CITY of NOVI CITY COUNCIL

Agenda Item ¹
September 8, 2008

SUBJECT: Consideration of the request of Titan Hotel Development, LLC, for approval of a Preliminary Site Plan, Wetland Permit, and Storm Water Management Plan for a proposed Hyatt Place Hotel at the Rock Financial Showplace. The applicant is proposing to construct a 5-story, 132-room hotel and parking lot expansion on 133.72 acres located on the north side of Grand River Avenue, west of Taft Road in the OST, Planned Office Service Technology District with an EXO, Exposition Overlay.

Attachment:
Revised conceptual layout for loading zone area

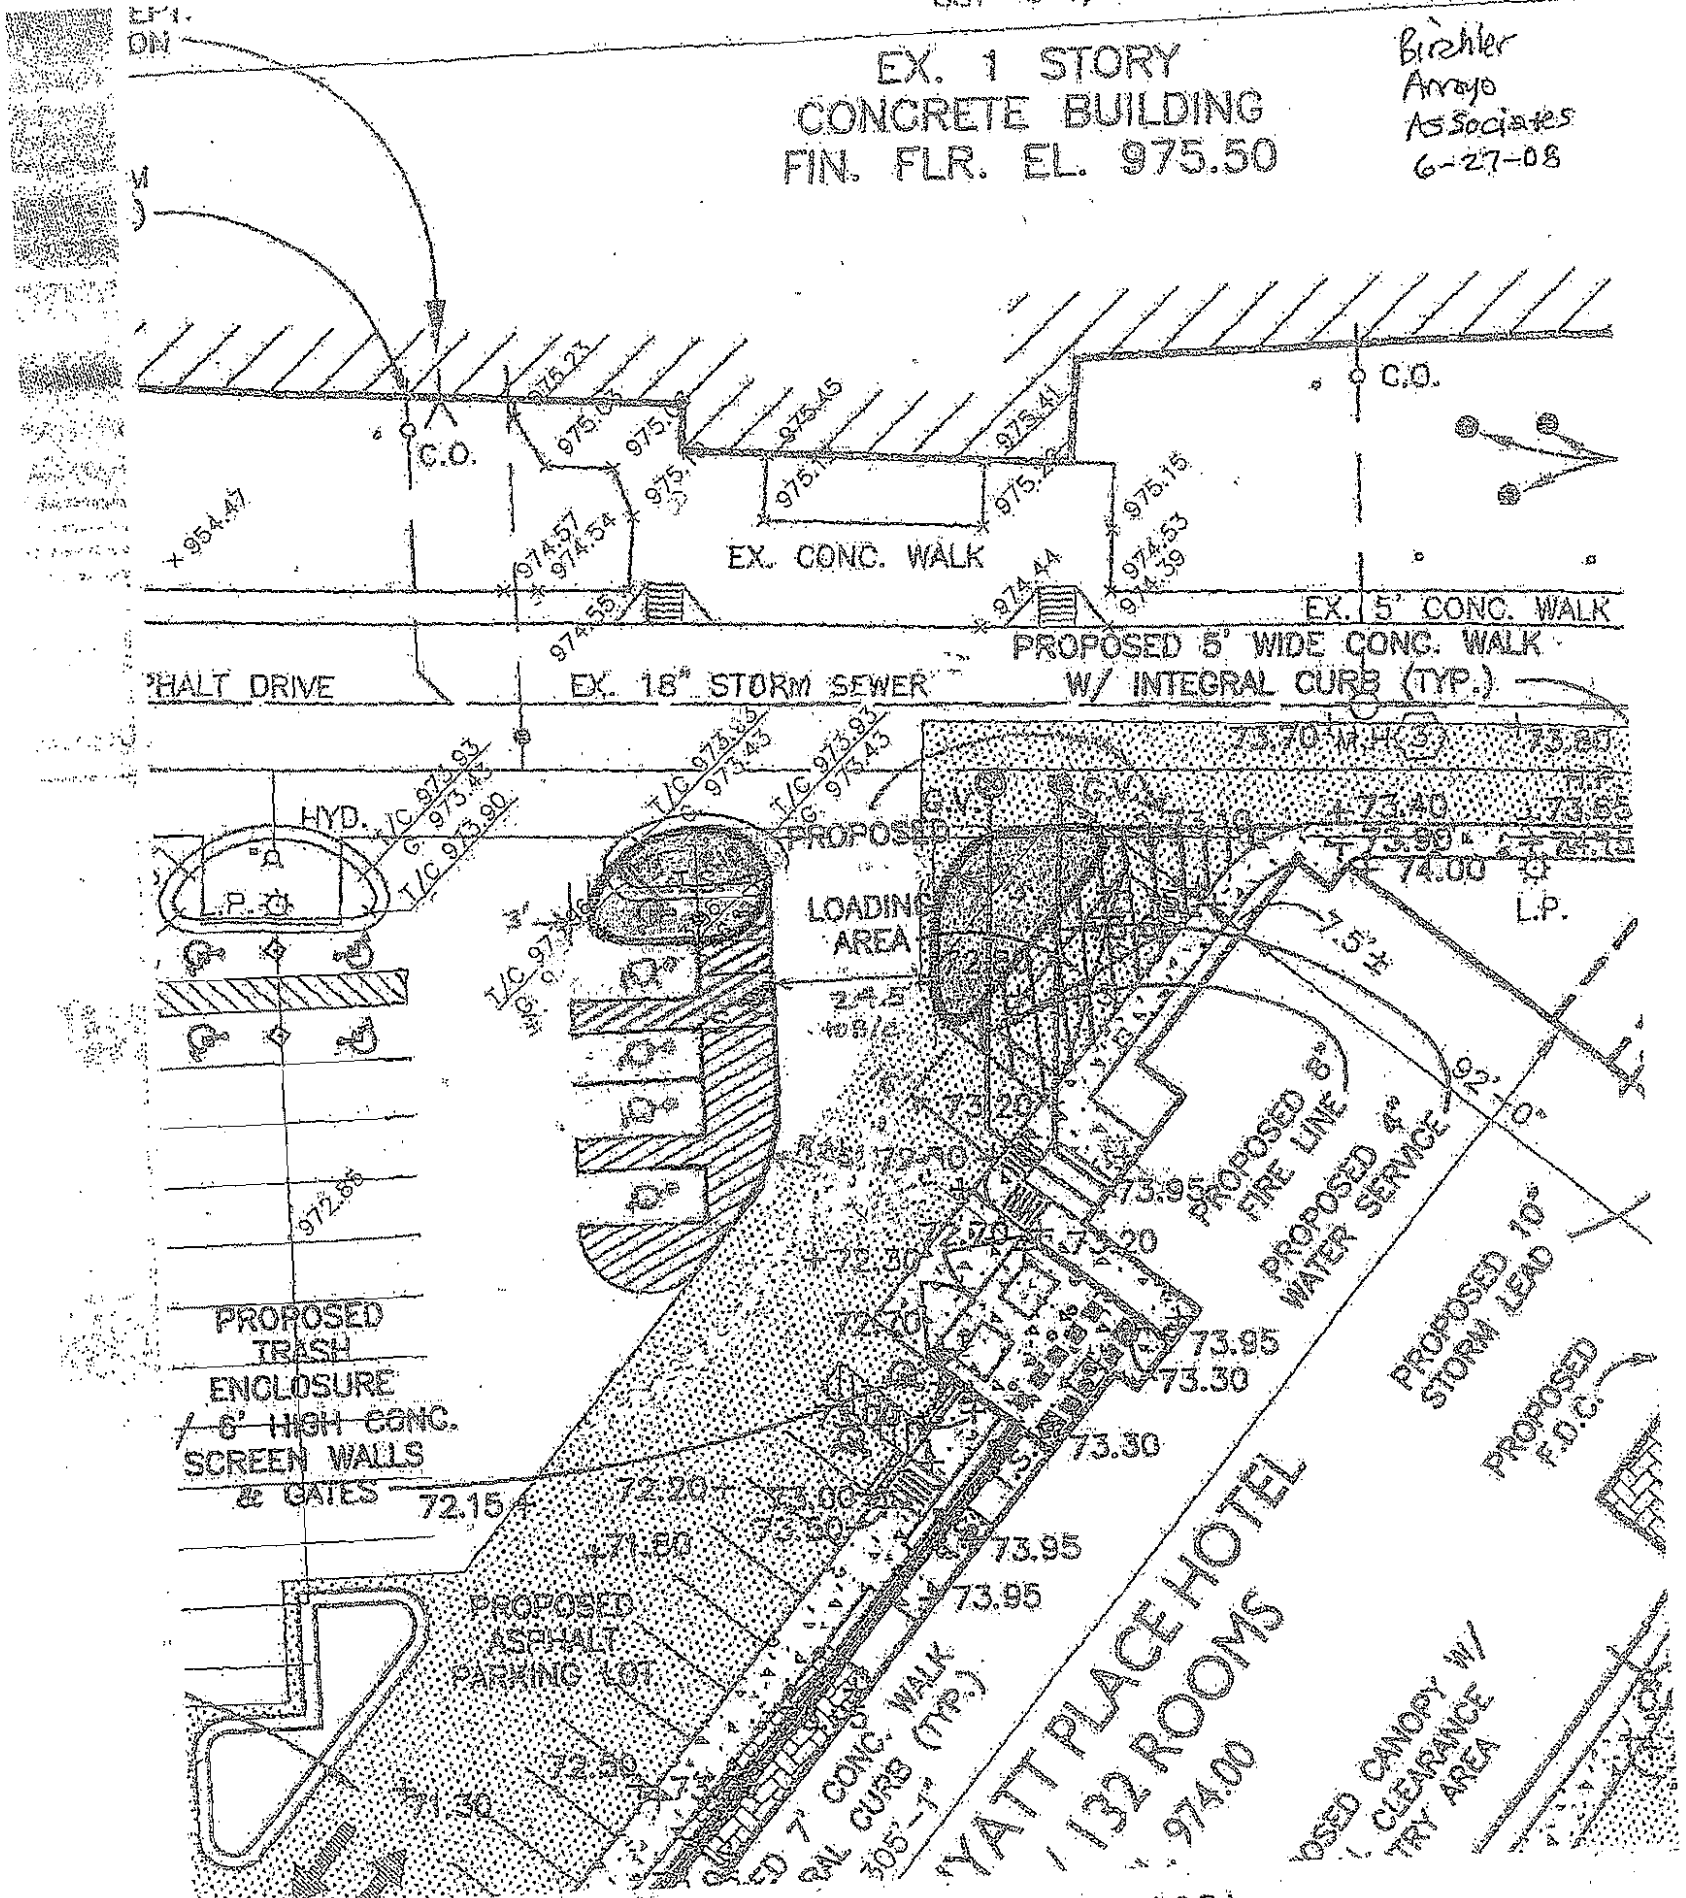
4. Since a traffic study was required, we will state that we have some issues with the methodology of the study as submitted. Particularly, we feel the impacts of the hotel should have been evaluated assuming an event at RFS of a large enough scale that the traffic signal at the main driveway is operational. The traffic counts conducted for this study at the existing RFS driveways were done during the peak commuter hours of Tuesday, May 8, 2007. Based on our conversation with management at RFS, the events held on that day generated "typical" weekday traffic. Figure 2 of the traffic impact study shows relatively small volumes of peak-hour traffic entering or exiting the site. We assume that the large-scale events at RFS that generate high traffic volumes occur on weekends, most likely with mid-day Saturday being the peak hour of RFS traffic. If the impacts of hotel traffic on the site driveways and off-site intersections were to be evaluated most usefully, counts would have been conducted during an event Saturday, and a peak-hour analysis on an event Saturday would have been included in the study. Particularly, the study may have shown the need to adjust the timing of the traffic signal at Grand River and the main RFS driveway, a signal that only operates during large RFS events.

The loading zone will not change as requested. The applicant believes this layout will better serve the required function. Detailed signing and striping plan for any new signage or pavement markings will be submitted with the final site plan.
